INTERNAL DOOR FRAME REPLACEMENT ON VENTED DRYERS.

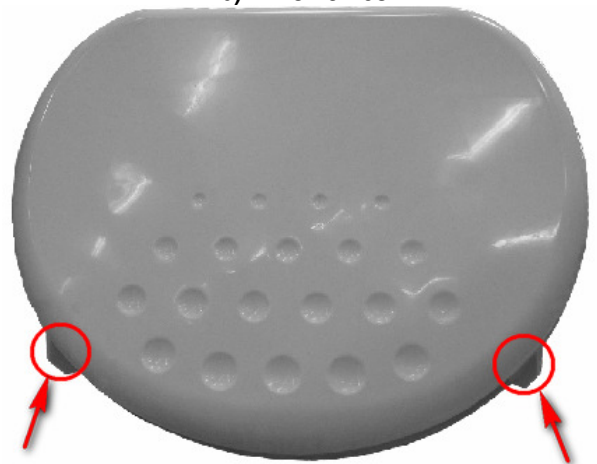
Reason for changing Internal Door Frame in vented dryers is to eliminate the possibility to get the laundry (with buttons) in the space between Air Duct and external surface of Internal Door Frame.

To eliminate possibility of going buttons to critical area it is necessary to change Internal Door Frame. New Internal Door Frame is equipped with additional flanges (marked in red).

Old Internal Door Frame:

- a) 125 792 010 6
- b) 125 792 030 4

New Internal Door Frame:

- a) 125 792 011 4
- b) 125 792 031 2

Modification was introduced into series production on 1st of February 2010.
